FIAN ECUADOR  
Wilson 547 y Almagro  
Quito, Ecuador  
Tel: 2547903  
Fax: 2224962  
sass@fianecuador.org

Comments regarding the Project design document (PDD) CDM (MDL, for its Spanish acronym) for the **Multipurpose Baba Hydroelectric Project (MBHP) located in the province of Los Ríos, Ecuador**

Turbines of Marcel Laniado de Wind Plant. The plaques indicate a maximum capacity of 64.68 (FIAN's file)

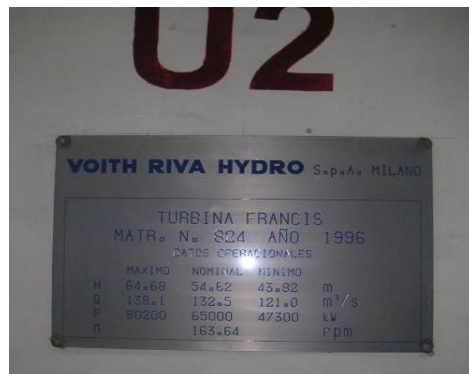
On the other hand, on page 2 the PDD asserts that MLW has 213 MW of installed capacity and 90 MW of generation. However, MLW has an actual installed power of 65 MW per unit - as stated in the Hidronación Journal of March 25, 2008, which declares that "since March 10 2008, MLW has been generating 65 MW per unit, at its *maximum* capacity"<sup>2</sup>. In light of the foregoing, the generation of 602 GWh/year added to the National Interconnected System (SNI, for its Spanish acronym) by the MBP is an inconsistent piece of information.

<sup>2</sup> See also photos of the data in the MLW turbines plaques, where it may be noticed that the rated power - the value used for operation and statistics recognized by CONELEC- is of 65 MW.
